**WIDEFIELD WATER AND
SANITATION DISTRICT**

2 MG ROLLING HILLS TANK

**SITE DEVELOPMENT PLAN
FINAL DRAINAGE REPORT**

**RE: Widefield Water and Sanitation District
2 MG Potable Water Tank
1041 Submittal – Drainage Letter
Address: TBD (Schedule 5500000385)**

WIDEFIELD WATER AND SANITATION DISTRICT
 ROLLING HILLS 2MG POTABLE WATER TANK AND INLET PIPELINE
 SITE DEVELOPMENT PLAN
 EXISTING SITE DRAINAGE

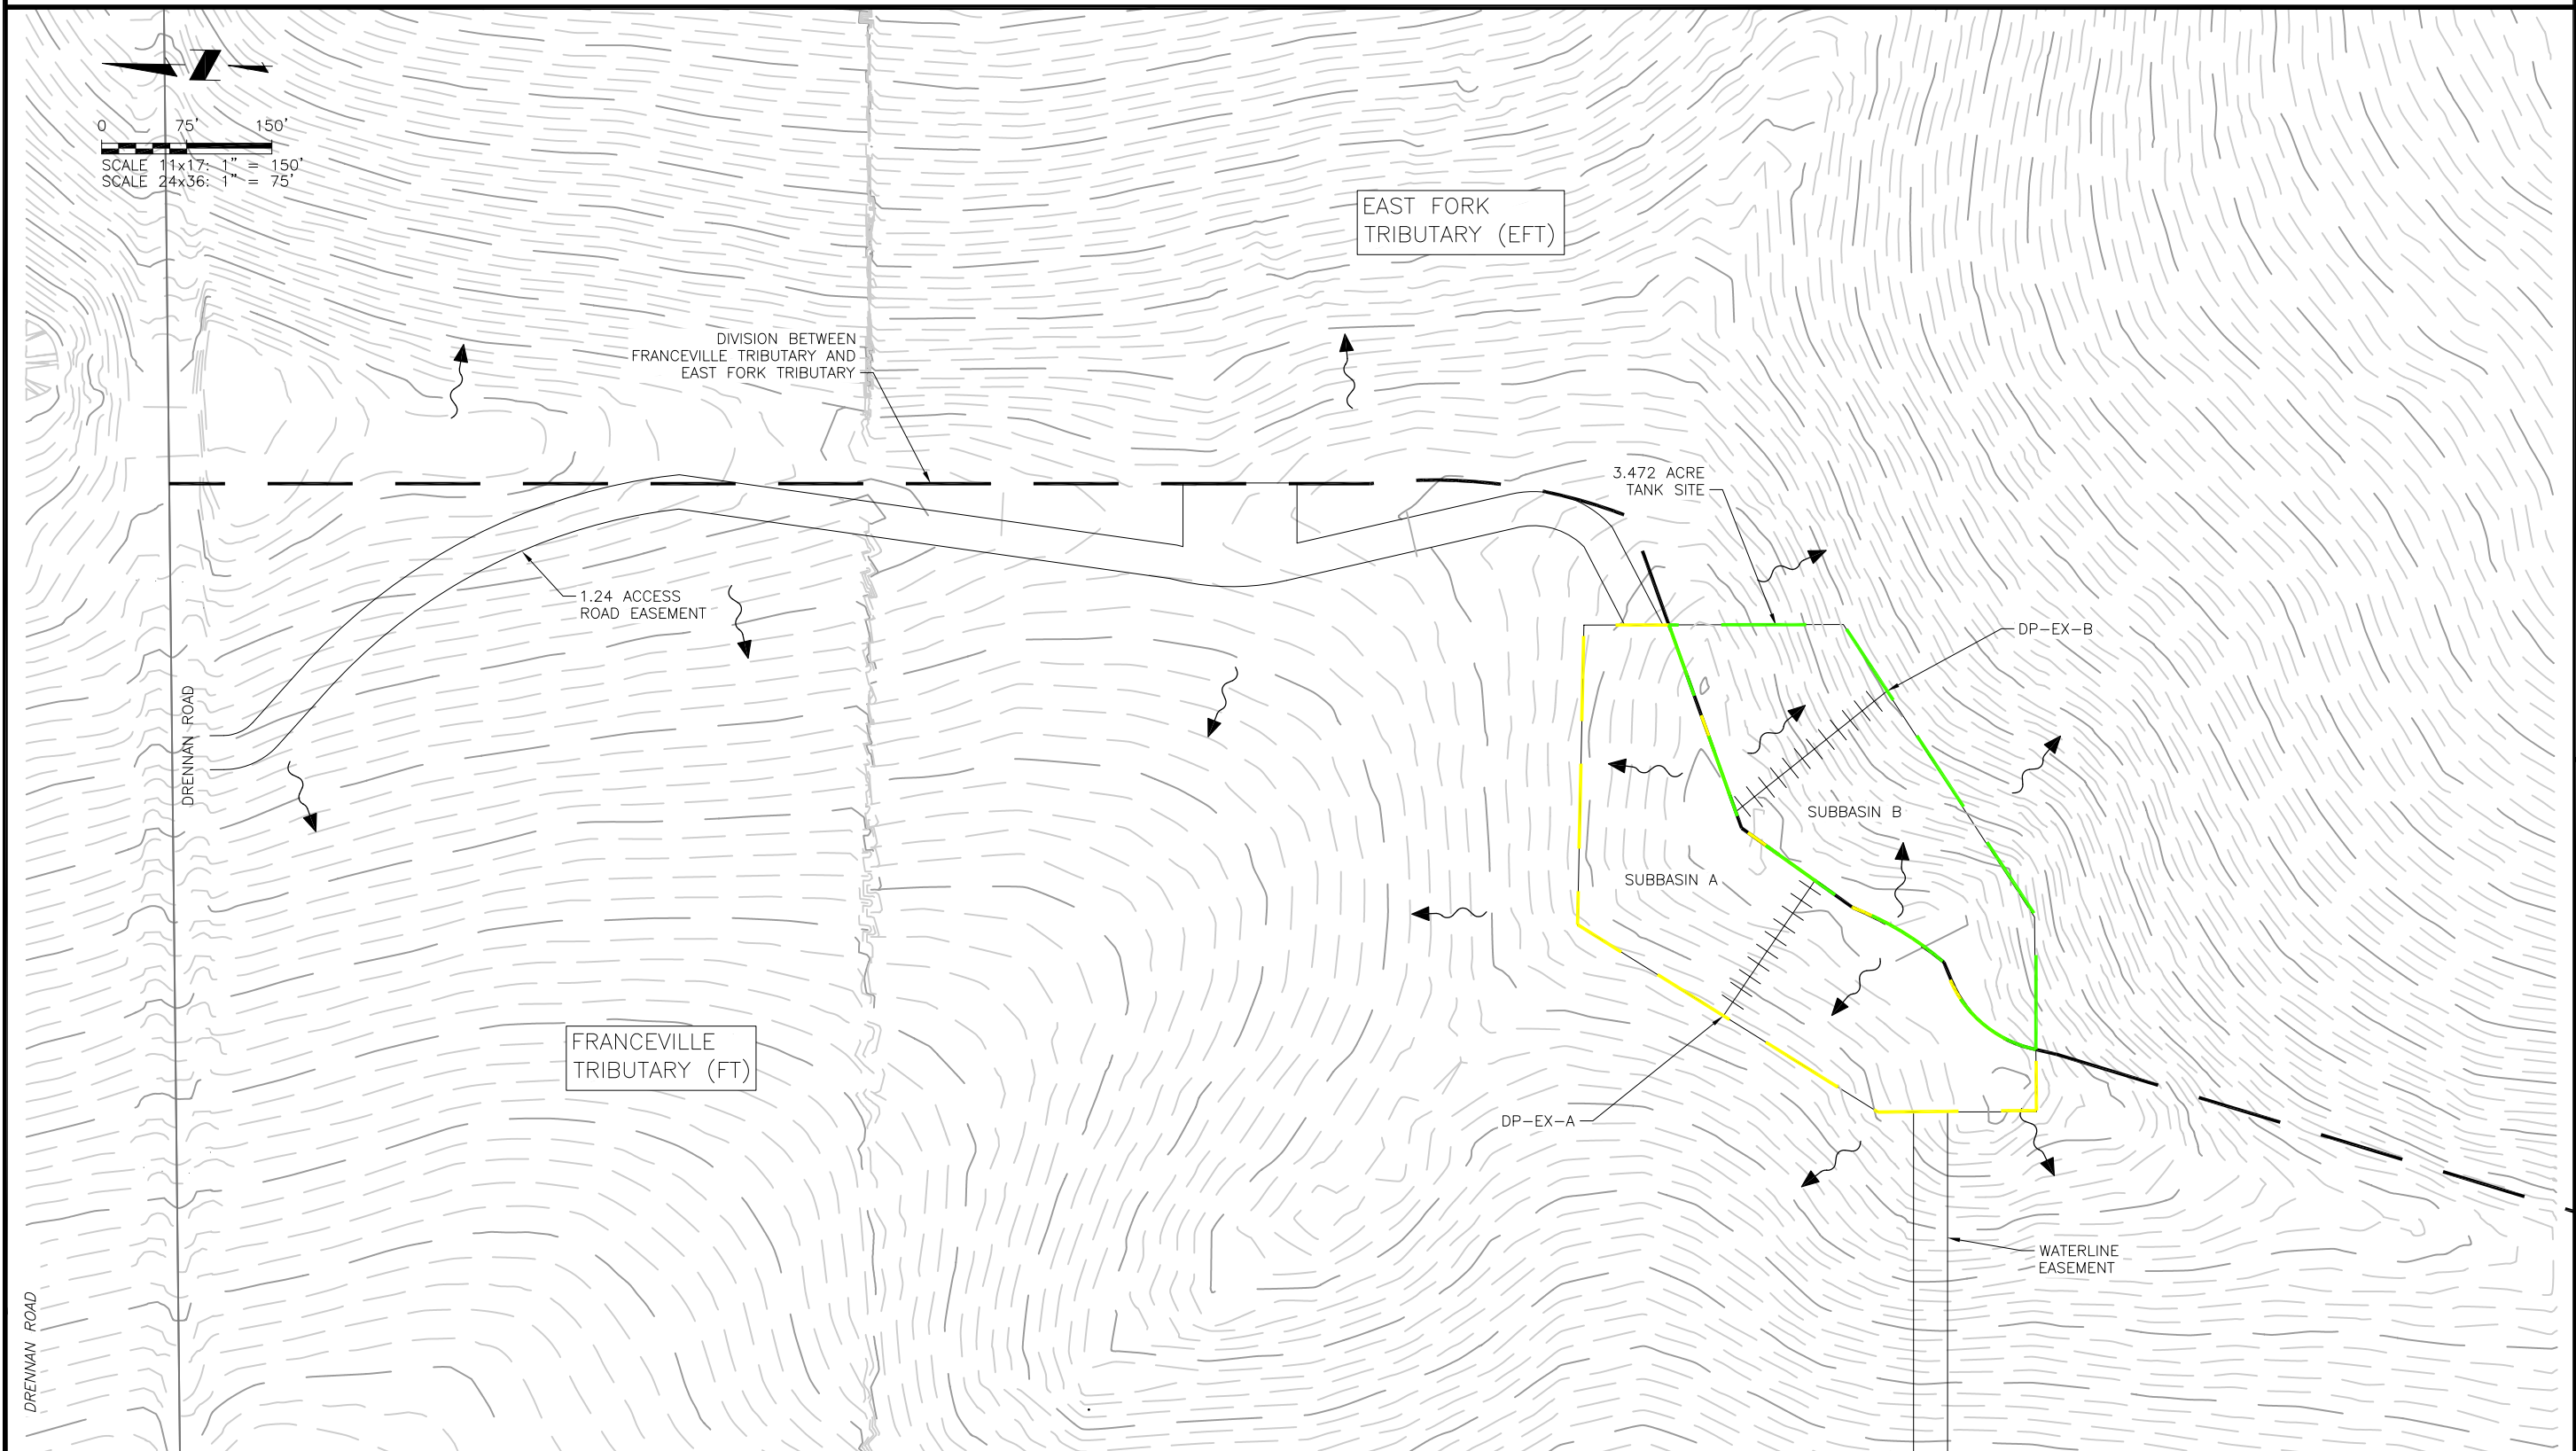
Please provide a design point & basin summary table basin areas and Q values

WIDEFIELD WATER AND SANITATION DISTRICT
 ROLLING HILLS 2MG POTABLE WATER TANK AND INLET PIPELINE
 SITE DEVELOPMENT PLAN
 PROPOSED SITE DRAINAGE

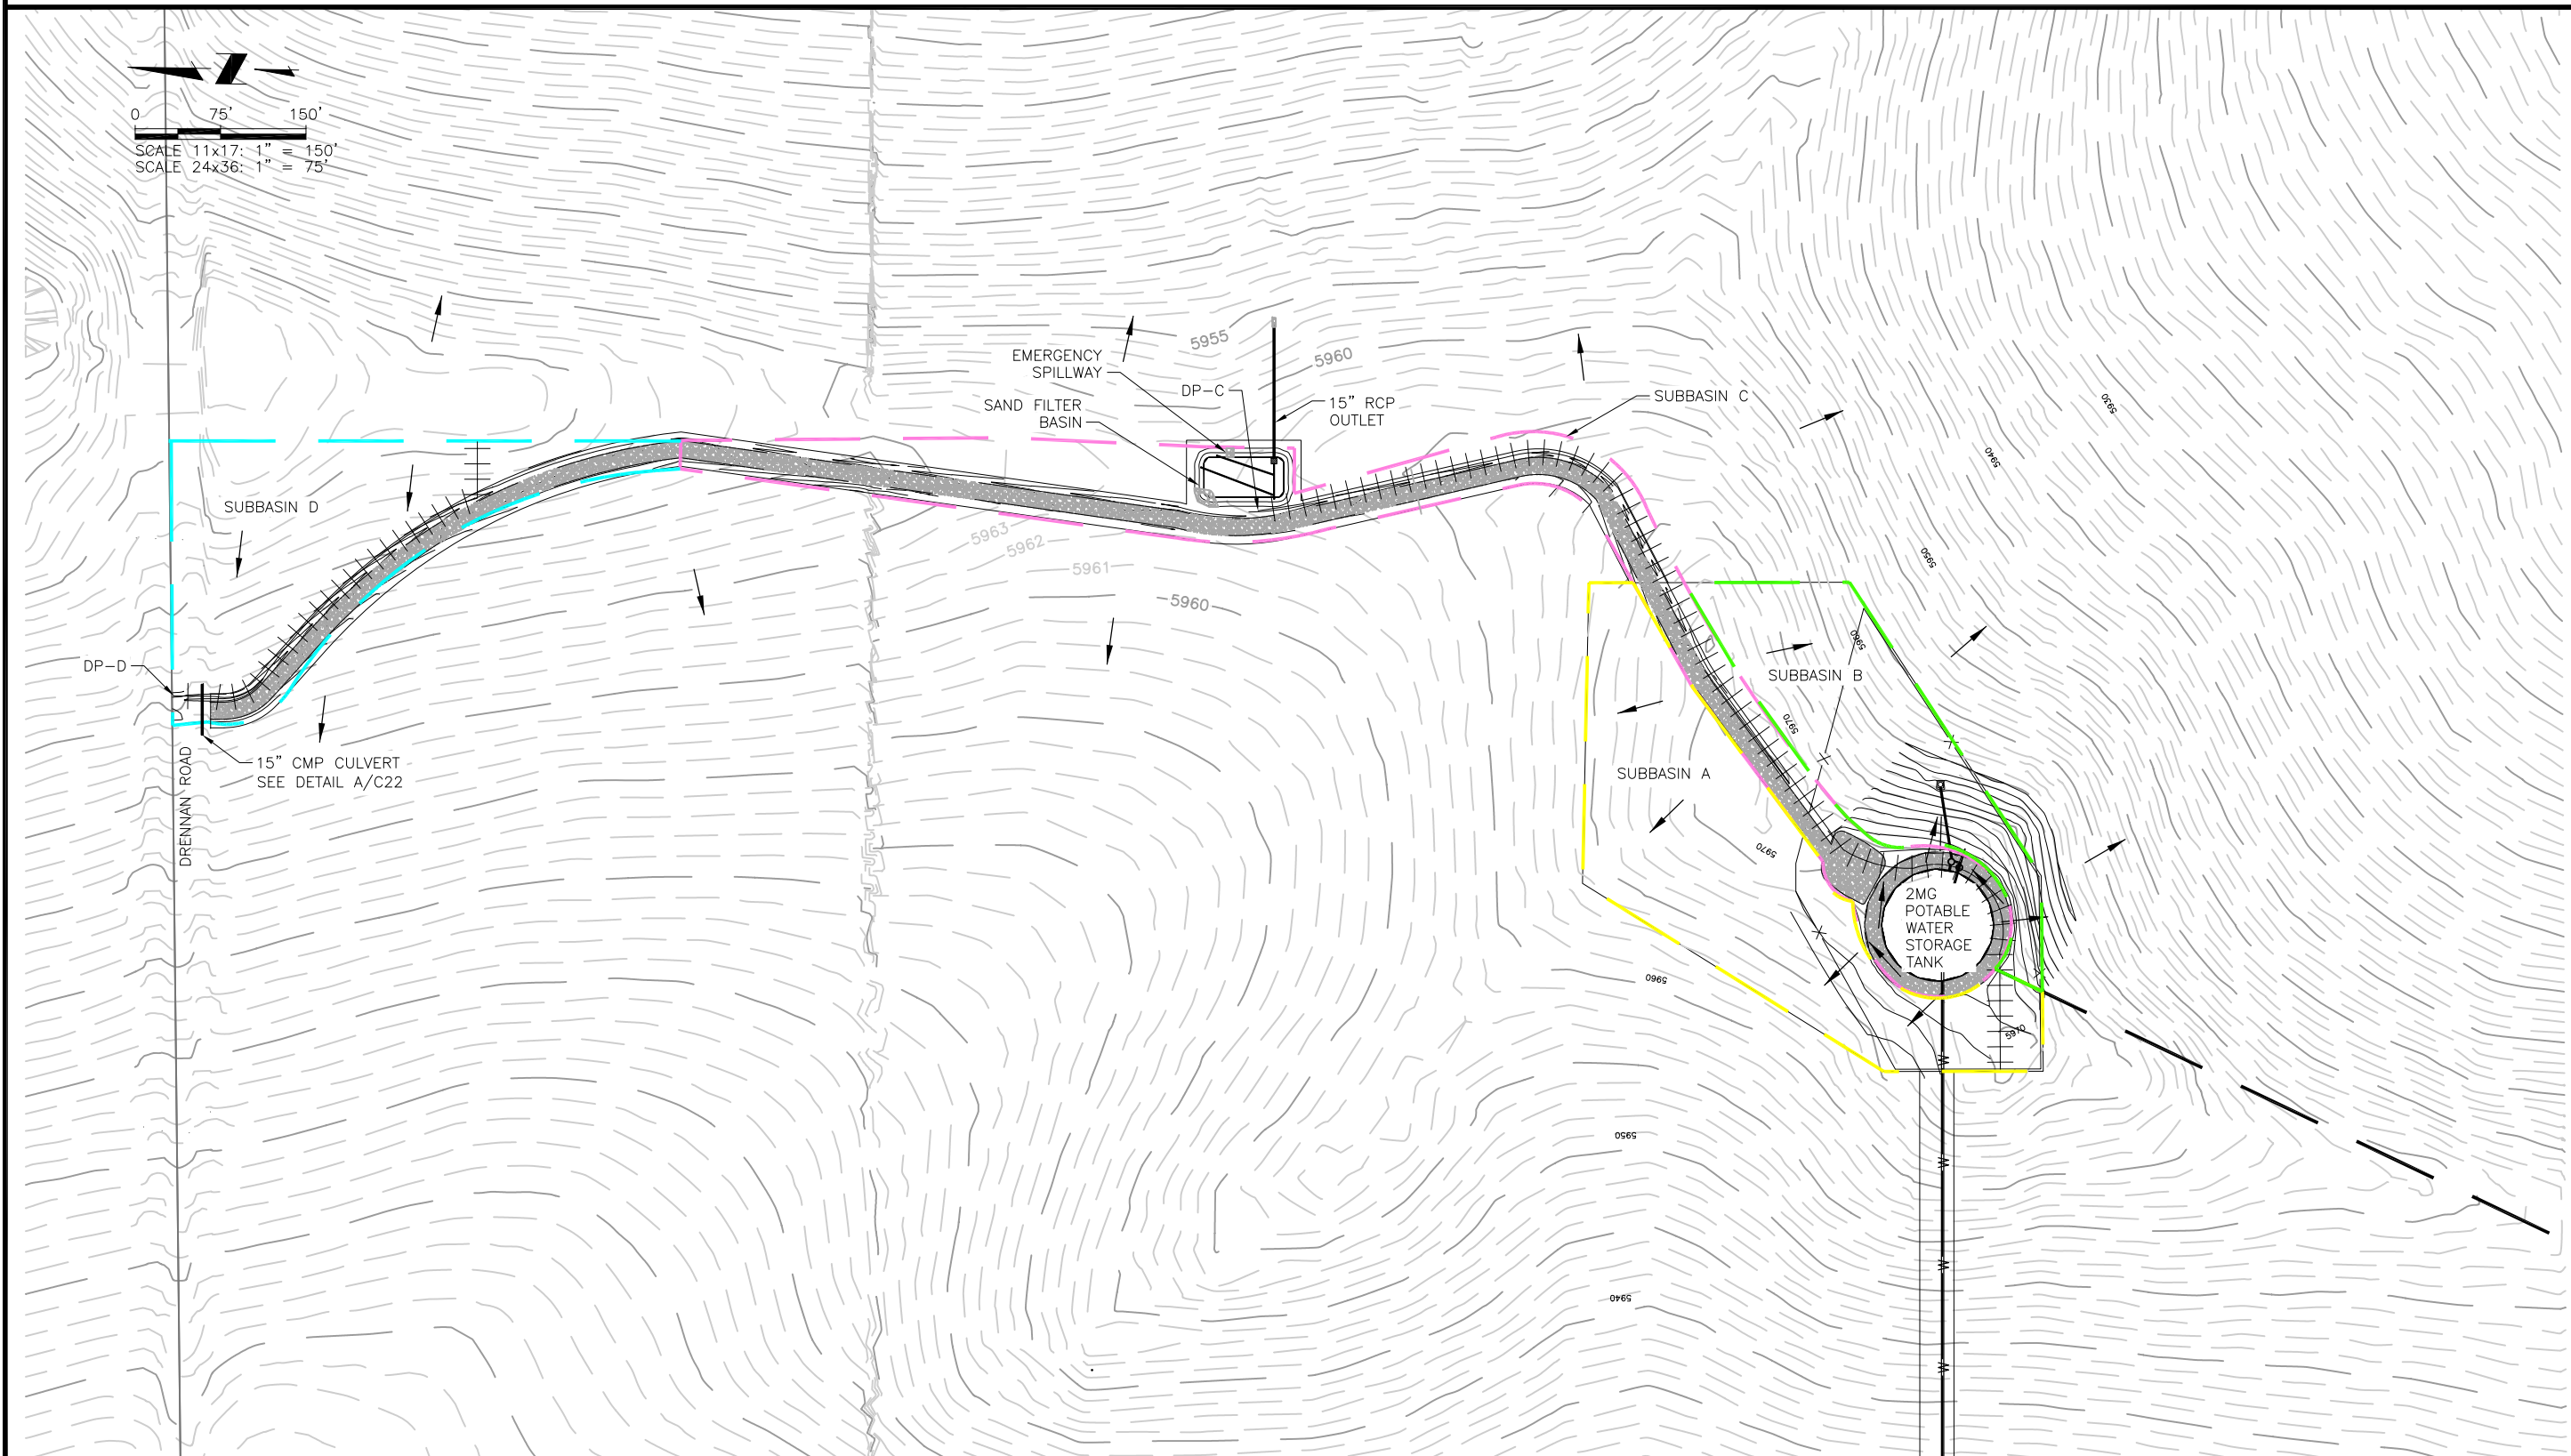
Please provide a design point & basin summary table basin areas and Q values

WIDEFIELD WATER AND SANITATION DISTRICT
ROLLING HILLS 2MG POTABLE WATER TANK AND INLET PIPELINE
DRAINAGE BASIN PLAN & PROFILE

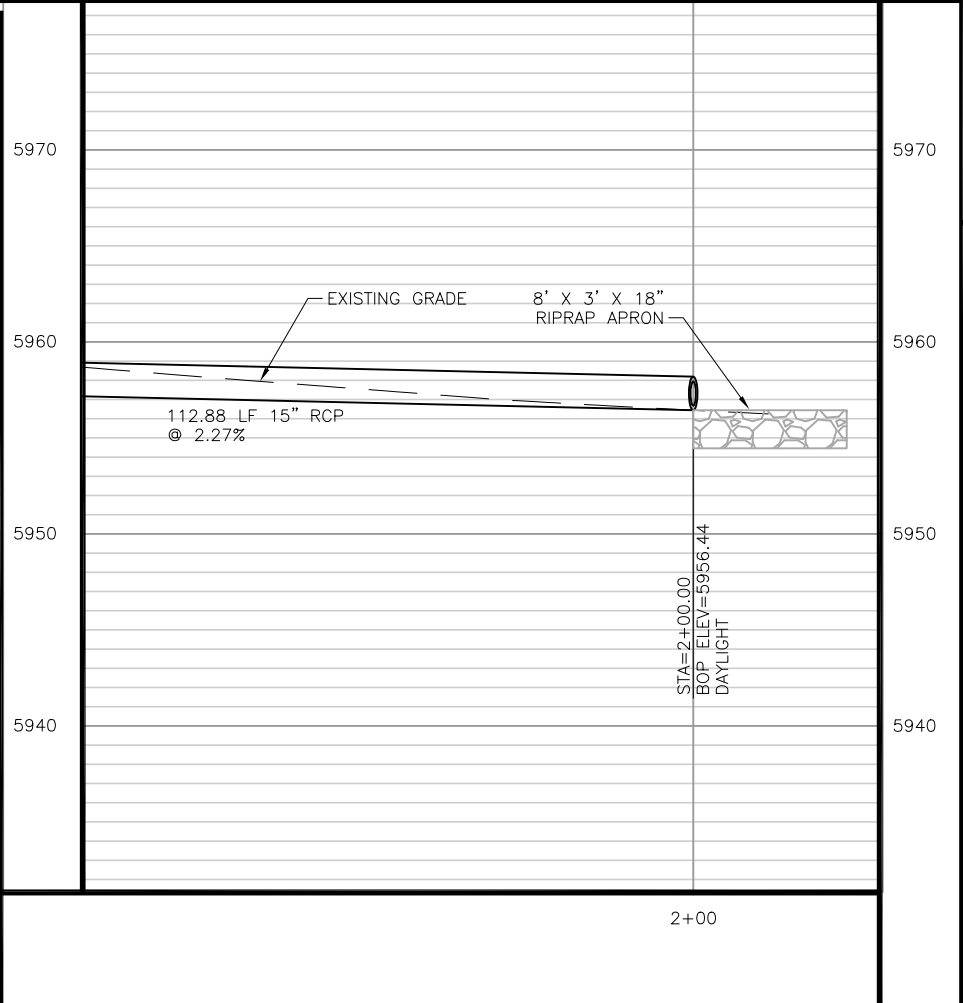
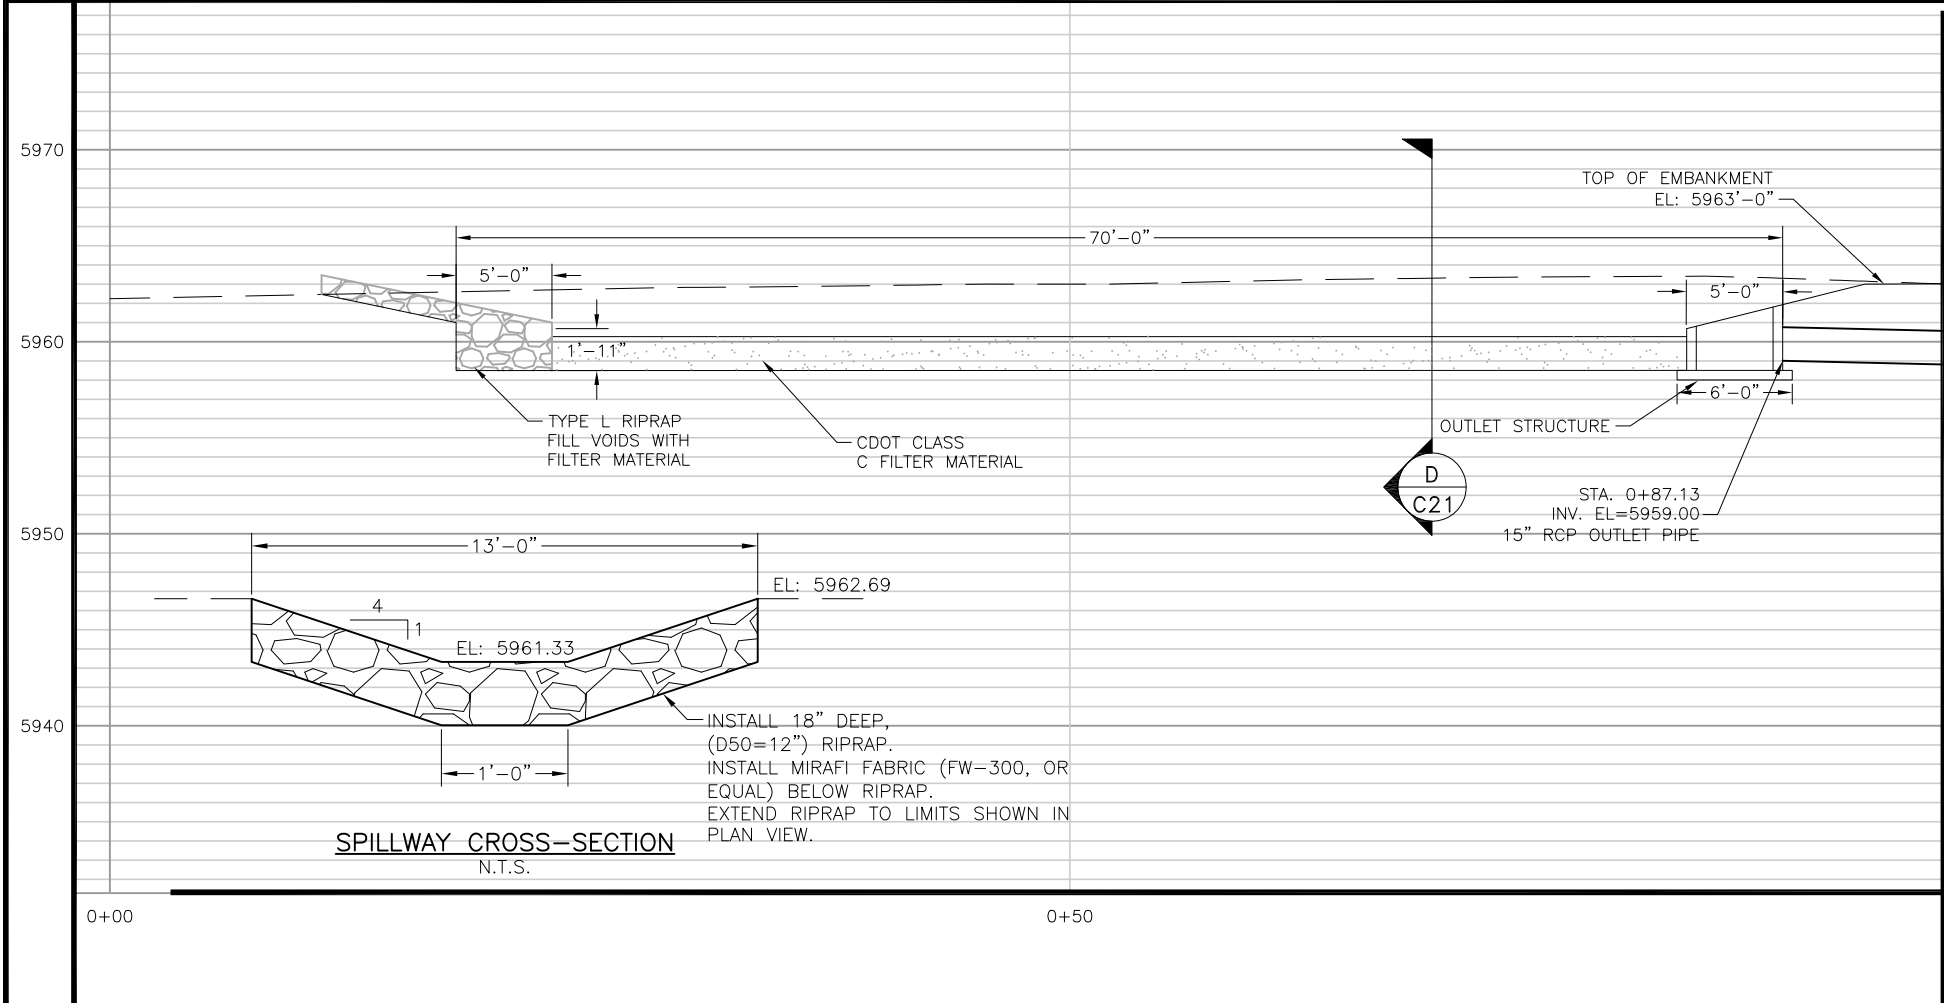
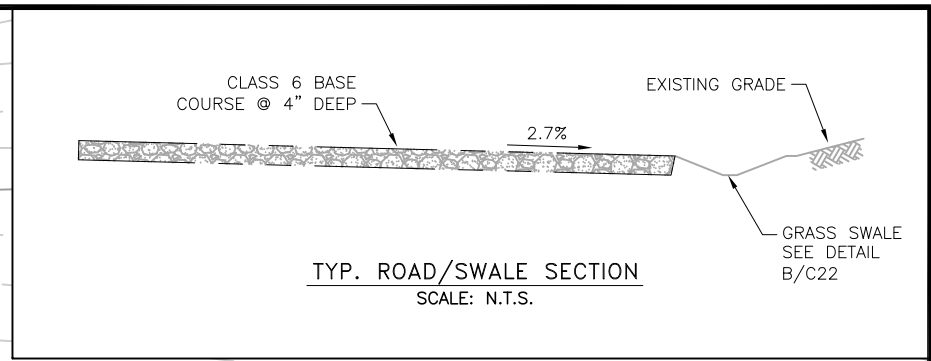
Please provide a note that indicates "for reference only" on these construction detail sheets within the drainage report.
